Tauntek

ARP 2600 ADSR Sustain Buffer Info

2600/TTSH Sustain voltage buffer:

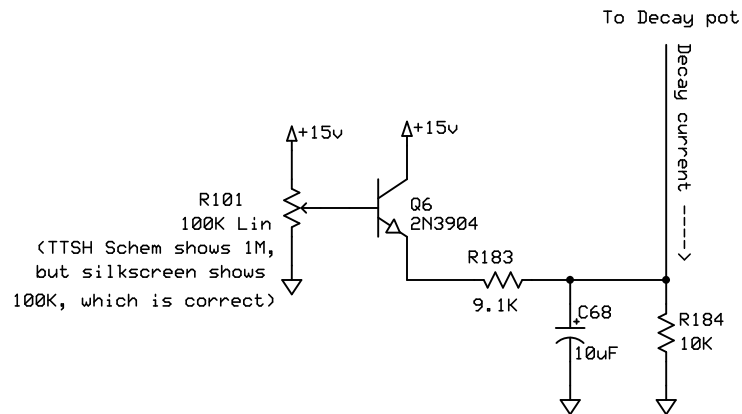
<TTSH Schem shows 1M,
but silkscreen shows
100K, which is correct>

Note that decay current tends to charge C68

This raises the sustain voltage.

If the ADSR is triggered fast enough, C68

doesn't have time to discharge to the correct level.

NPN can only source current, so it doesn't help

Odyssey Sustain voltage buffer:

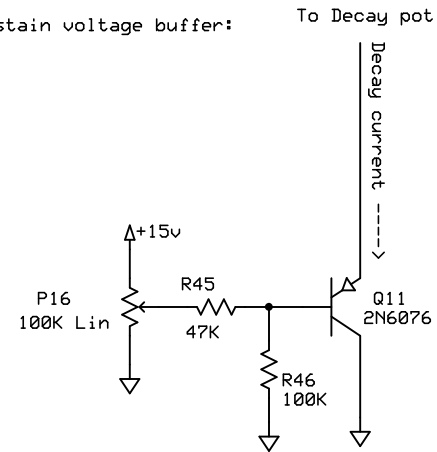
PNP emitter-follower supplies decay current

No cap is needed

Since PNP needs 0.6V across base-emitter
we can't actually get 0V sustain level.

But, it works in the Odyssey, so probably OK.

Could connect P16 to -1V instead of ground.

Or use an op amp instead of Q11
